Access Compliance Report

Public Rights-of-Way

(Curb Ramps)

Intersection ID: 53147	Main Street: ACHIEVEMENT_LN	Cross Street: NEW_RENAISSANCE_WY	Location: SE
ADA ID: 789B2D113596	Ramp Type: Perp	Initial Pass/Fail: Pass	Overall Compliance: No
Severity Score: 0.25			
Codes/Mitigation Info/Possible Solution		Field Measurements/Component Compliance

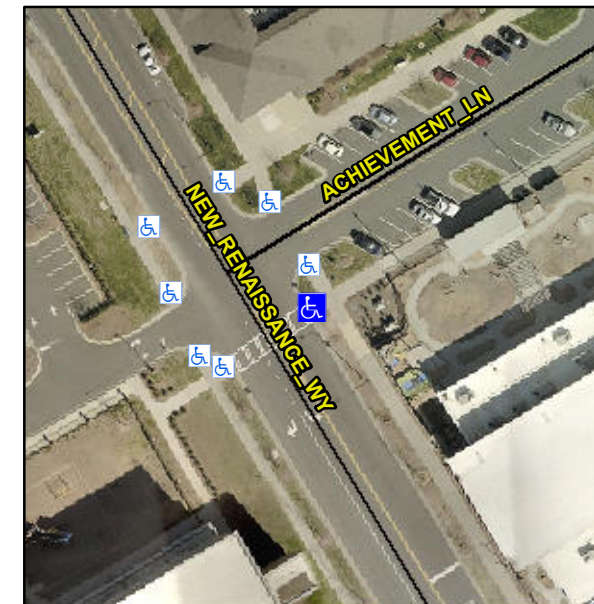
R304.5.3, R305.2

Compliance	Description	Data	Compliance	Description	Data
N/A	Ramp Length (in)	81.0	Yes	Ramp Slope (%)	5.1
Yes	Ramp Width (in)	96.0	No	Ramp XSlope (%)	2.6
Yes	Flare Type L	Curbed_NoWalkSurface	Yes	Flare Type RT	N/A
Yes	Flare Slope LT (%)	N/A	N/A	Flare Slope RT (%)	N/A
N/A	Flare Traversable LT?	No	N/A	Flare Traversable RT?	No
Yes	Landing Length (in)	104.0	Yes	DWS Provided?	Yes
Yes	Landing Width (in)	96.0	Yes	DWS Contrast?	Yes
Yes	Landing Slope (%)	0.7	Yes	DWS Length (in)	24.0
Yes	Landing X Slope (%)	0.1	Yes	DWS Full Width?	Yes
N/A	Landing Curb? (Y/N)	No	No	DWS Offset (in)	11.0
N/A	Shared Landing?	No			
Yes	Gutter Ponding?	No	Yes	Gutter Slope (%)	1.2
Yes	Gutter Lip Ht (in)	0.0	Yes	Gutter X Slope (%)	0.7
N/A	Painted X Walk1?	No	N/A	Painted X Walk2?	N/A
	X Walk 1 Direction	To SW		X Walk 2 Direction	N/A
N/A	X Walk 1 Width (in)	N/A	N/A	X Walk 2 Width (in)	N/A
	X Walk 1 Slope (%)	2.7		X Walk 2 Slope (%)	N/A
	X Walk 1 X Slope (%)	0.5		X Walk 2 X Slope (%)	N/A

N/A	Ramp inside XWalk1?	N/A	N/A	Ramp inside XWalk2?	N/A
	Road Slope (%)	N/A	N/A	Clear Space?	Yes
	Road X Slope (%)	N/A	N/A	Clear Space to XWalk (in)	N/A
Yes	Any Obstructions?	No	Yes	Storm Grate/Utility Hazard?	No
	Obstruction Type			Storm Grate/Utility Type	
		N/A			N/A
			Yes	Surface Condition? (G/P)	Good

Remove & Replace Entire Ramp.
